Access Compliance Report

Public Rights-of-Way

Intersection ID: 45539	Main Street: PEACHTREE_RD	Cross Street: CORVUS_CT	Location: SW
ADA ID: 65451792FD45	Ramp Type: Perpendicular Diagonal	Initial Pass/Fail: Fail	Overall Compliance: No
Severity Score: 10			
Codes/Mitigation Info/Possible Solution		Field Measurements/Component Compliance

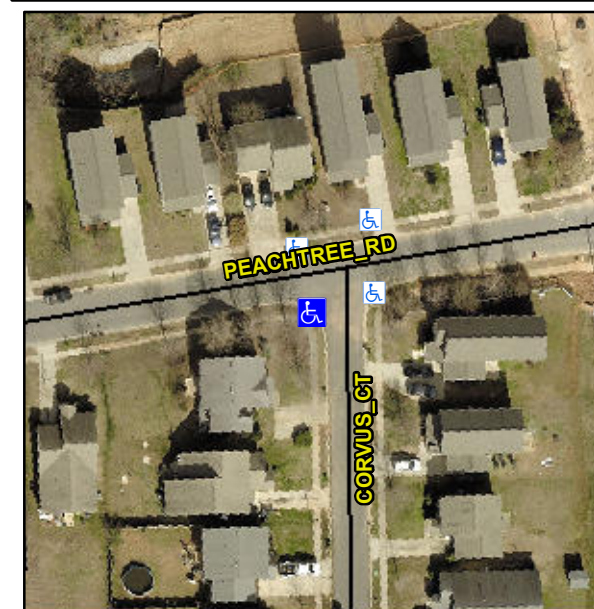
Not Found, R304.5.1, R304.5.3

Compliance	Description	Data	Compliance	Description	Data
N/A	Ramp Length (in)	48.0	Yes	Ramp Slope (%)	5.1
No	Ramp Width (in)	45.0	No	Ramp XSlope (%)	4.5
N/A	Flare Type LT	N/A	N/A	Flare Type RT	N/A
N/A	Flare Slope LT (%)	N/A	N/A	Flare Slope RT (%)	N/A
N/A	Flare Traversable LT?	N/A	N/A	Flare Traversable RT?	N/A
N/A	Landing Length (in)	N/A	N/A	DWS Provided?	N/A
N/A	Landing Width (in)	N/A	N/A	DWS Contrast?	N/A
N/A	Landing Slope (%)	N/A	N/A	DWS Length (in)	N/A
N/A	Landing X Slope (%)	N/A	N/A	DWS Full Width?	N/A
N/A	Landing Curb? (Y/N)	N/A	N/A	DWS Offset (in)	N/A
N/A	Shared Landing?	N/A			
N/A	Gutter Ponding?	N/A	N/A	Gutter Slope (%)	N/A
N/A	Gutter Lip Ht (in)	N/A	N/A	Gutter X Slope (%)	N/A
N/A	Painted X Walk1?	No	N/A	Painted X Walk2?	No
	X Walk 1 Direction	To E		X Walk 2 Direction	To N
N/A	X Walk 1 Width (in)	N/A	N/A	X Walk 2 Width (in)	N/A
	X Walk 1 Slope (%)	1.5		X Walk 2 Slope (%)	2.7
	X Walk 1 X Slope (%)	0.7		X Walk 2 X Slope (%)	2.3

Remove & Replace Curb Ramp With Two New Directional Ramps or Equivalent.
